**WOODWARD HIGH SCHOOL REOPENING PHASE 2
MANDATORY REFERRAL NO. MR2023017
FOREST CONSERVATION PLAN NO. F20230360**

Description

Mandatory Referral review for Phase 2 construction of Charles W. Woodward High School including an addition on the north side of the main school building, the upper floor of a parking deck, athletic fields, and associated stormwater management.

Nos. MR2023017 &
F20230360

Figure 7: Site Circulation

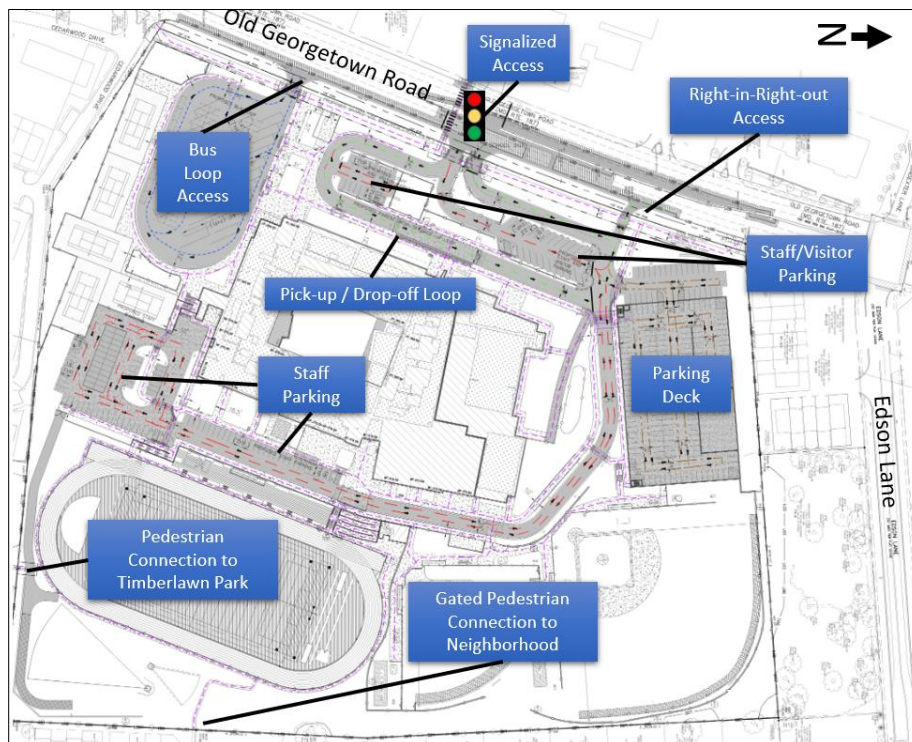
Phase 1 developed the vehicular access to the Property. Phase 2 does not modify the vehicular access to or circulation within the Property, except for the addition of a parking deck on the parking lot located at the northwest corner of the site and the addition of the emergency access driveway to the stadium.

Figure 10: Variance Tree Removals and Preservation. Trees to be removed in red, trees to be preserved in green.

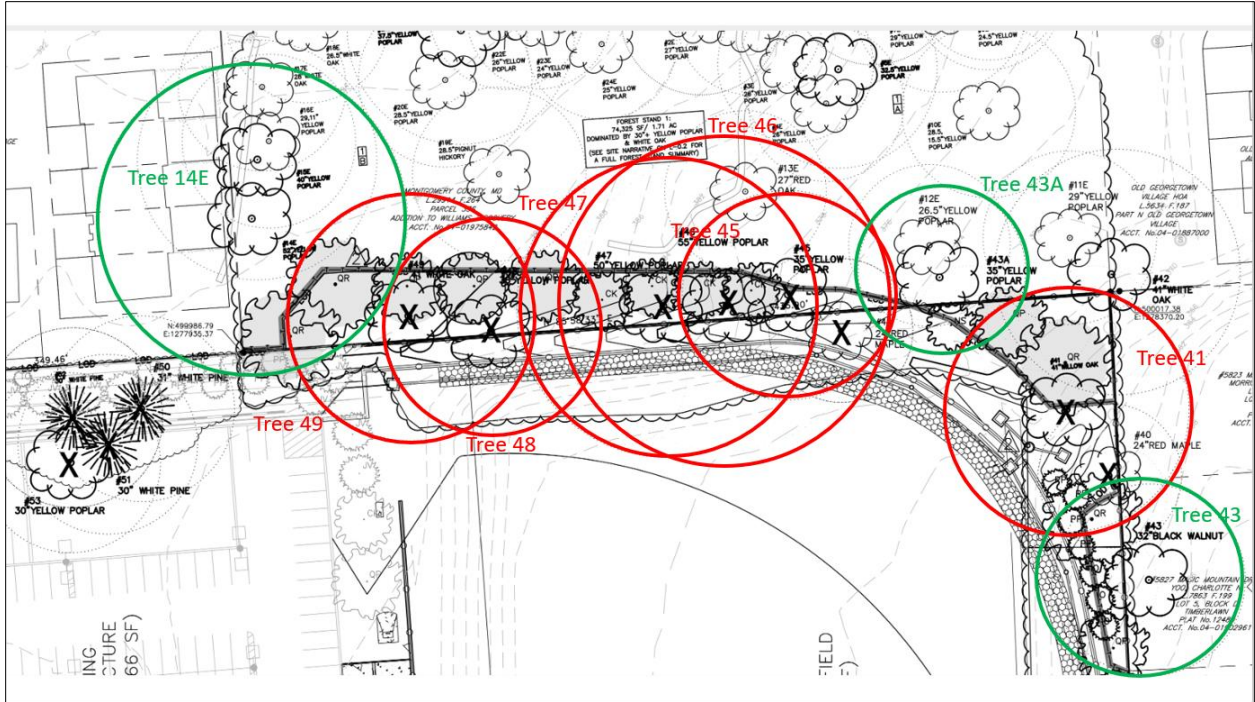
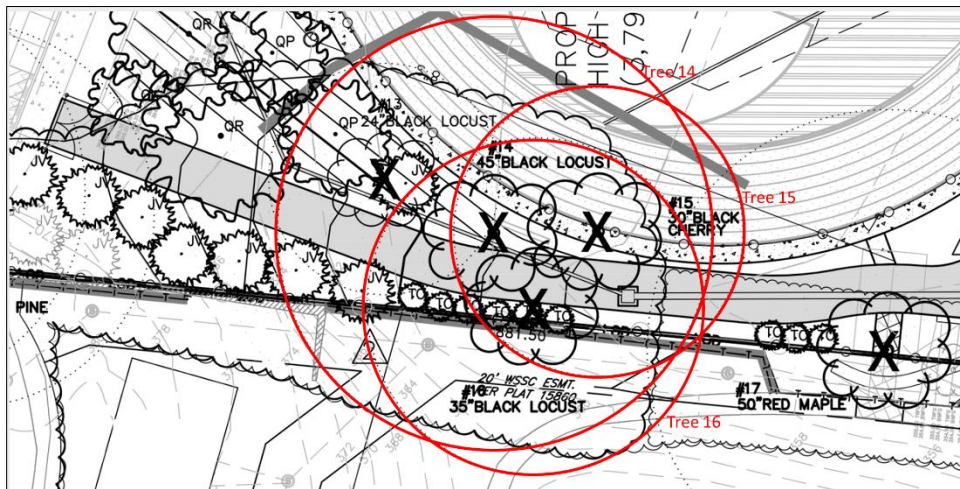
On August 4, 2023, the Applicant submitted an amended variance request in association with the FFCP (Attachment G). As stated, the amendment updates the disturbance of the root zones to include an additional nineteen (19) specimen trees. Sixteen (16) of the impacted trees will be required to be removed and are considered high priority for retention under Section 22A-12(b) (3) of the County Forest Conservation Law. The Applicant proposes to impact, but save, an additional three (3) trees that are 30 inches or greater DBH, that are considered high priority for retention (Tables 2 & 3).

Per Section 22A-21, a variance may only be considered if the Planning Board finds that leaving the requested trees in an undisturbed state would result in unwarranted hardship, denying the Applicant reasonable and significant use of its property. In this case, the unwarranted hardship is caused by the necessary layout of the proposed development on the Property which is dictated by the existing site constraints, including site size, topography requiring grading to create building pads and stabilize steep slopes, required school facilities, Montgomery County agency requirements including stormwater management, and required utilities. Trees No. 14E, 41, 43, 43A, 45, 46, 47, 48, and 49 are located near the northern site boundary where they are being impacted by construction of a new baseball diamond, a retaining wall and associated grading. Trees No. 23, 25, 27, 29A, 29D, 30 and 64

are located along the eastern site boundary, and are impacted by ballfield and stadium construction, retaining walls, grading and stormwater management. Trees No. 14, 15, and 16 are located along the southern site boundary where they are impacted by grading and a required ambulance access road to the stadium. The inability to remove these trees would potentially render portions of the site undevelopable for this project. Therefore, there is a sufficient unwarranted hardship to justify a variance request because the Applicant would otherwise be unable to provide the athletic facilities required to serve the high school student population, which is a reasonable and significant use of the Property, which is being dedicated to construction of a high school and its associated facilities.

There are 16 Protected Trees proposed for removal in this variance request, resulting in a total of 590 inches of DBH being removed. The Applicant proposes mitigation at a rate that approximates the form and function of the trees removed. These trees will be replaced at a ratio of approximately 1-inch caliper for every four inches removed using trees that are a minimum of three caliper inches in size. This results in a total mitigation of 147 inches with the installation of 49 3-inch caliper overstory trees native to the Piedmont Region of Maryland on the Property outside of any rights-of-way and outside of any utility easements. The locations of these plantings must be shown on the certified Final Forest Conservation Plan. Although these trees will not be as large as the trees lost, they will be planted on the Subject Property and provide some immediate benefit, ultimately replacing the canopy lost by the removal of these trees. There is some disturbance within the CRZ of three trees; however, they will receive adequate tree protection measures, their roots will regenerate, and the functions they currently provide will continue. Therefore, no mitigation is recommended for trees that are impacted but retained. It has been M-NCPPC policy not to require mitigation for Protected Trees removed within forest stands since the removal of the forest is accounted for through the Forest Conservation Worksheet. As conditioned, the mitigation trees will be protected as part of a 5-year maintenance and management agreement.

Staff recommends approval of the variance request.
